Comanche Peak Nuclear Power Plant, Units 3 & 4
COL Application
Part 2, FSAR

2.4.4 Potential Dam Failures

CP COL 2.4(1)

~~Replace the content~~Add the following at the end of DCD Subsection 2.4.4 with the following.

Figure 2.4.4-204 Dams Upstream of Lake Whitney Dam

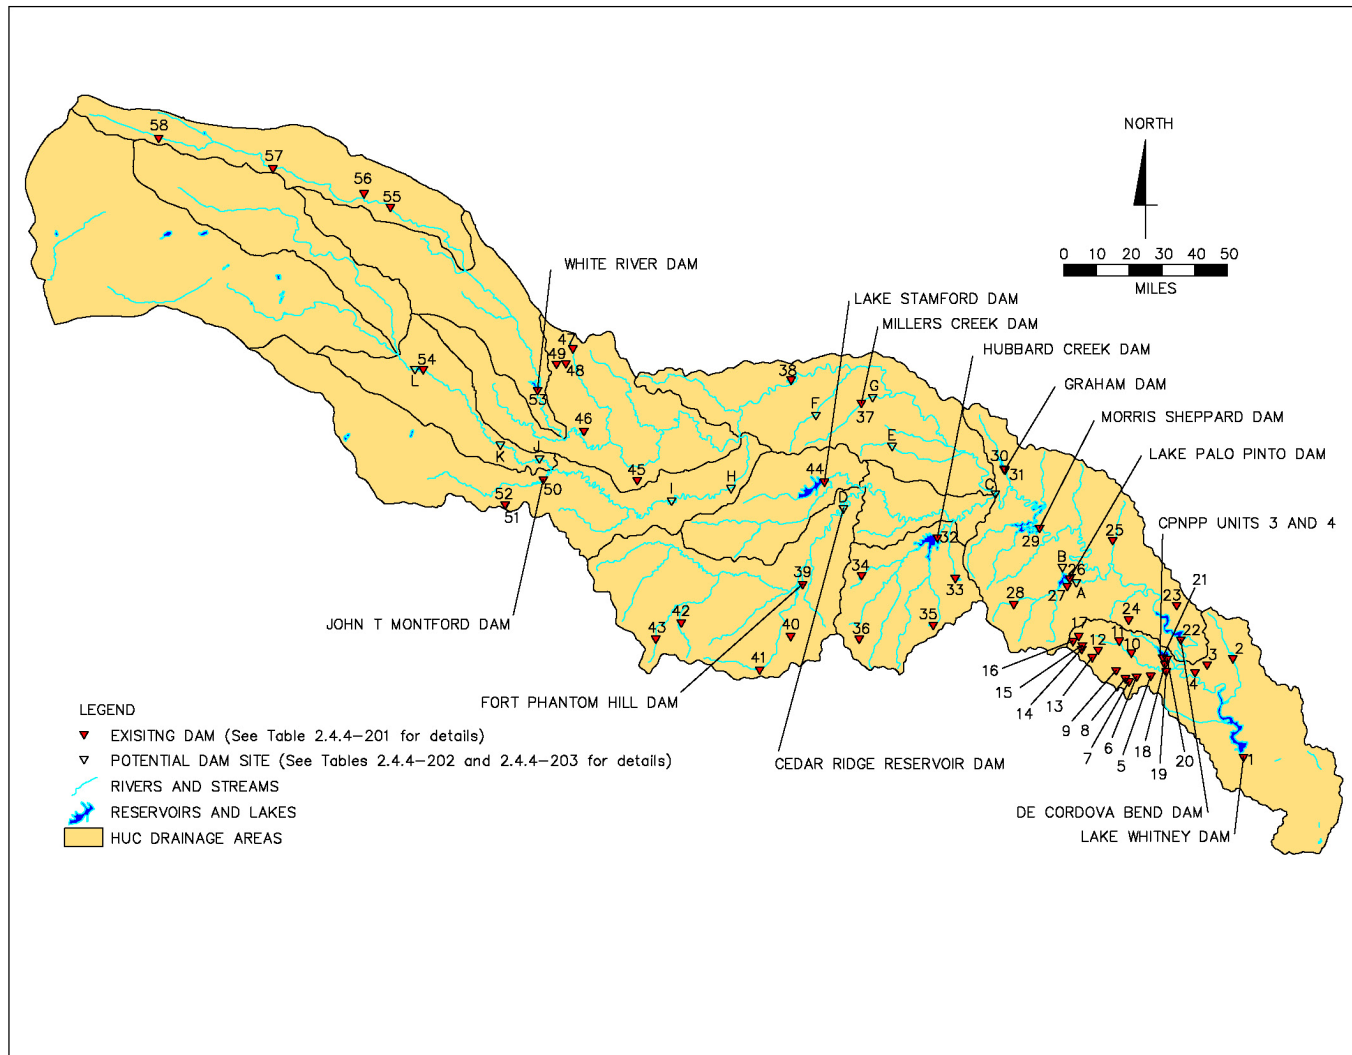
The distance from the confluence, reservoir storage, dam height, and drainage area are used as the basis for a qualitative assessment of dams to determine dam failure permutations that would warrant a quantitative assessment. Considering existing conditions, information for dams located in the Lake Whitney watershed has been obtained from the National Atlas (Reference 2.4-274), supplemented with information obtained from the U.S. Army Corps of Engineers National Inventory of Dams database (2.4-222), and is provided in Table 2.4.4-201. Wheeler Branch Dam and the associated Paluxy River Channel Dam are recently completed structures and have not been included in the National Atlas. Data for these structures have been obtained from the Somervell County Water District (Reference 2.4-275) and the 2011 Brazos G Regional Water Plan (Reference 2.4-276). The locations of the dams are shown on Figure 2.4.4-204.
